FINAL PLAT

RIVERSIDE HOSPITAL 1ST ADDITION

WICHITA, KANSAS

Re: S/D 88-96 - RIVERSIDE HOSPITAL ADDITION, West of Maize
Road, approx. 1/4 mile south of Central

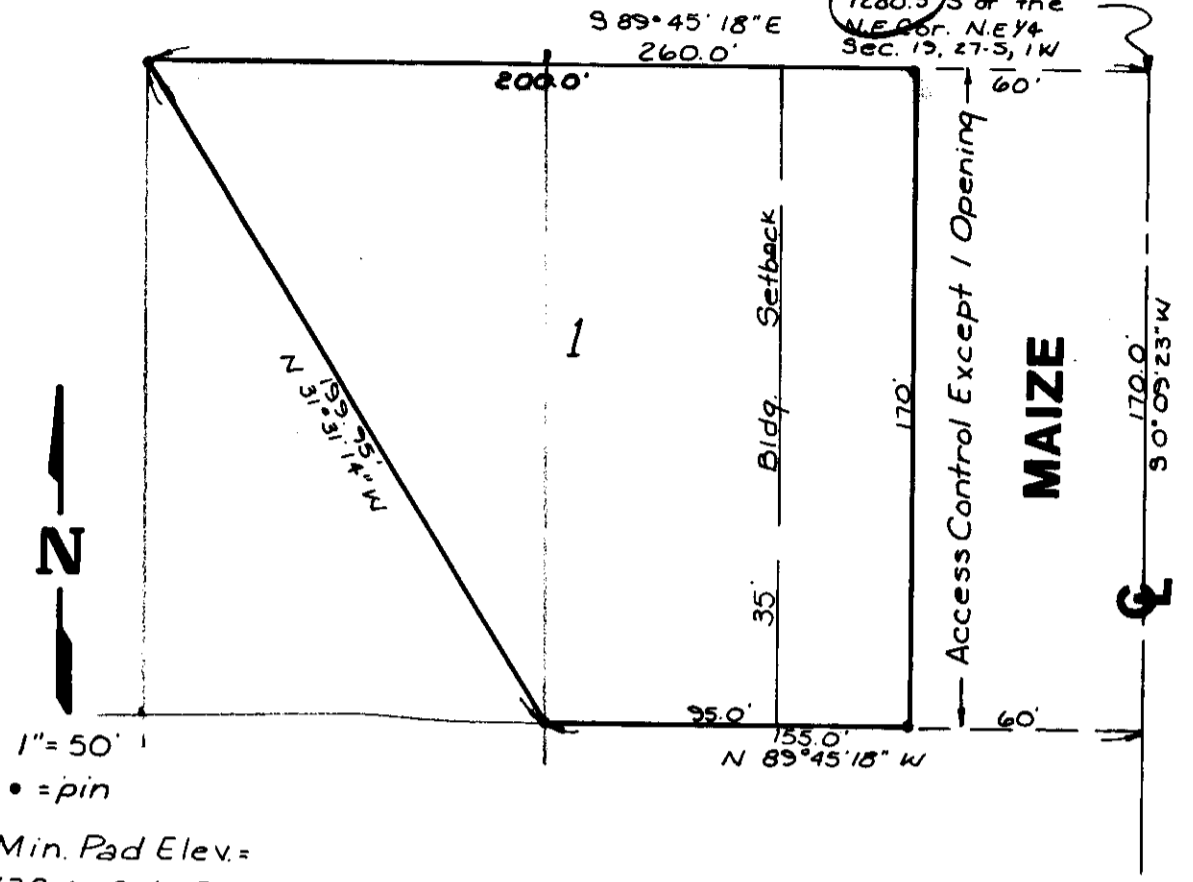
- A. The applicant shall either guarantee the extension of sanitary sewer or obtain the permission of Sewer Maintenance to connect to the existing sanitary sewer manhole within street right-of-way.

- B. The applicant shall guarantee a decel lane adjacent to this plat, along Maize Road. This guarantee will be held and activated only if traffic conditions at this site warrant the improvement.

- D. Prior to this plat being scheduled for City Council review, the applicant shall submit to City Engineering for approval, a revised drainage plan.
- E. As this property is establishing minimum building pad elevations, the face of the plat shall reference the location and elevation of permanent on-site and off-site benchmarks. Section 5-402(N). The minimum building pad elevation for this plat shall be shown as 137.6 City Datum. This elevation shall also be indicated in Mean Sea Level.

- F. The final plat tracing shall indicate a 10-foot building setback from the west property line.
- G. As requested by K.G. & E., the final plat tracing shall indicate a 10-foot utility easement along the north line of the plat.

- J. Perimeter closure computations shall be submitted with the final plat tracing. Section 5-101(c).
- K. Recording of the plat within 30 days after approval by the City Council.
